## **Section 2 – Response to Comments**

**Re: SCBP Buildings 1 & 2 Project**

*Figure 4- View from backyard of home neighboring proposed project. Note height of wall that will impact aesthetics of home. Red line added for effect to show where top of wall is projected to be using flagpole set-up by developer.*

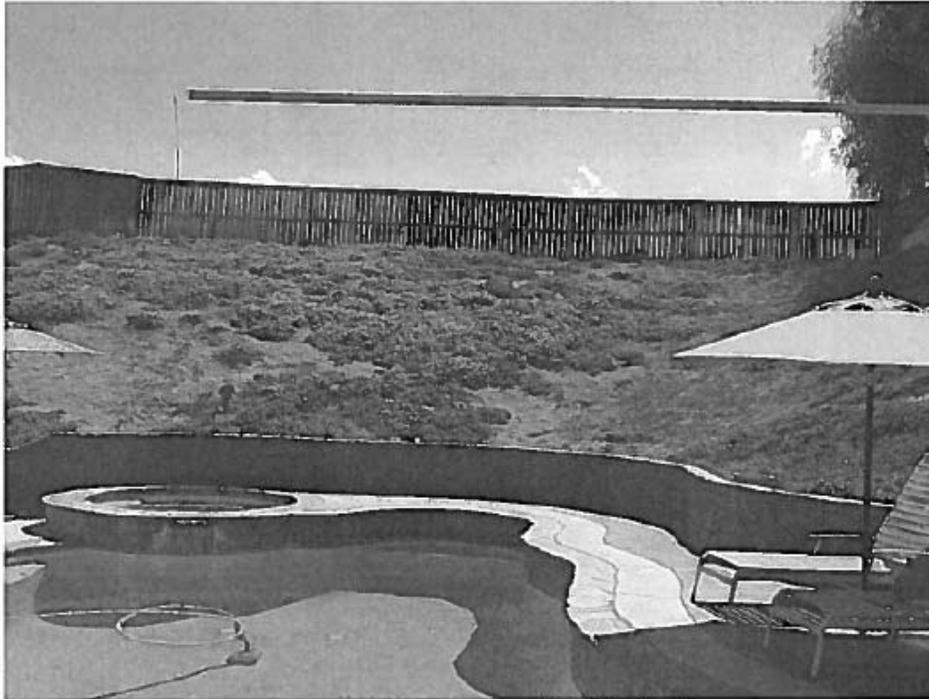
*Figure 3: View from backyard of northern residential properties. The flag represents the height of the wall and corner of proposed building nearest the northern residences. Red line added for emphasis of TOP of wall. View below will be that of large concrete wall replacing view.*
